Number: TSB-FC-2016-279 CS7000 Exhaust wrap kits

Model Name: CS7000 (All Gasoline and LP) & Haram Captor II

LEV or Pre-LEV Engine identification:

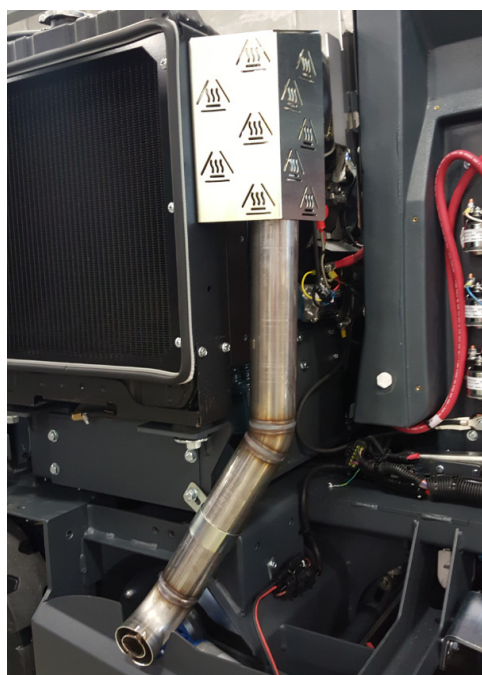
NOTE : see page 3 for LEV and Pre-LEV engine identification

New tube in tube exhaust

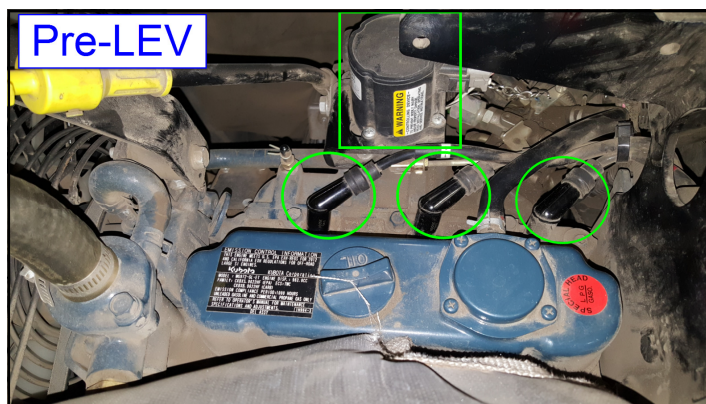
The exhaust pipe, exhaust silencer and exhaust tailpipe and their exhaust wraps have been replaced with a one piece tube in tube exhaust pipe. The stainless steel tube in tube design is able to shield heat without additional exhaust blankets thus preventing debris or condensation from being trapped between the exhaust pipes and silencer and the blankets.

SPARE PARTS or Kits Needed:

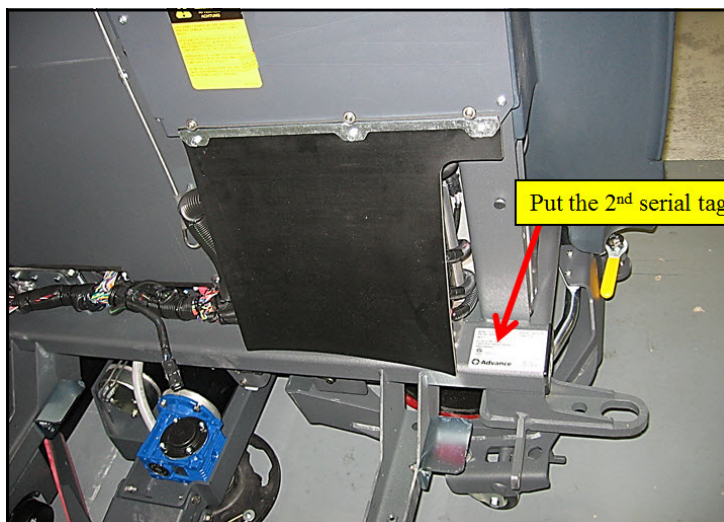
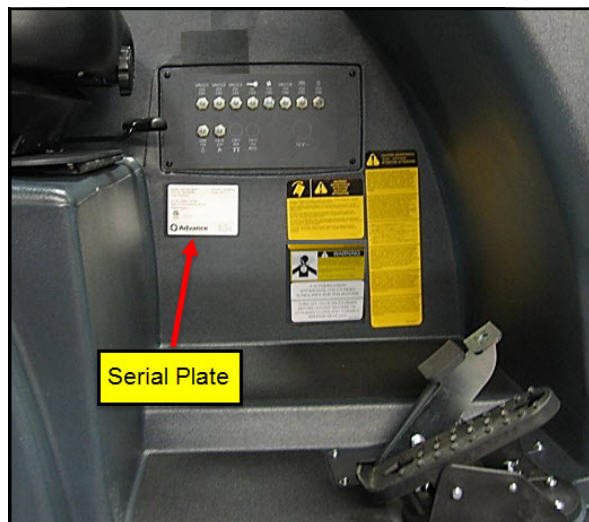
Th exhaust blankets kit and full blanket kits are no longer available and have been replaced by a new stainless steel Tube-inTube design that no longer requires exhaust blankets. Individual parts from the kits are still available, see page 5 for details.

56511717 EXHAUST PIPE KIT-CARBURETED for carbureted engines

56511718 EXHAUST SYSTEM KIT-EFI (electronic fuel injection) for newer LEV engines with EFI

56511719 EXHAUST SYSTEM KIT-CARBURETED for carbureted engines
